Attn:	The Secretary
Re: Case No	PAX16.324258
Local Authority:	Mayo County Council
Developers:	Constant Energy Limited
Development Location:	Ballymurphy, Ballynaleck, Barnhill lower, and Upper, Barroe, Billoos, Carn, Carrickanass, Carrowmore, CastleLacken Demesne, and other townlands in co mayo. Ballina Co Mayo
Development Description:	16 No Wind turbines Tirawley wind farm Strategic Infrastructure Development
Objection:	
Fee:	Fee attached of €50.00

I wish to object to the above development for a number of reasons as set out hereunder.

Plate 11.1: Proposed Penalty Scheme

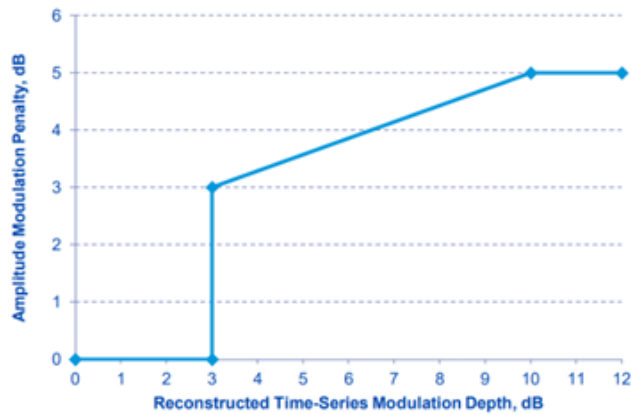
The most recent information in relation assessing AM comes in the IEC TS 61400-11. The scope of this document includes an assessment of the sound characteristics of the noise and relies on the Institute of Acoustics Reference Method (IoA RM) to quantify the AM level along with the WSP Phase 2 Report which identified a penalty scheme as shown **Plate 11.1** below.

The above is extracted from the Noise Section of the report and specifically states that the AM cannot be predicted at the planning stage so how can the developer say it is safe for a community to live around the foot of such a development when it cannot be measured. With Respect ABP must investigate such a coastal location with recorded high wind speeds, especially towards the Gasebo Side of the development.
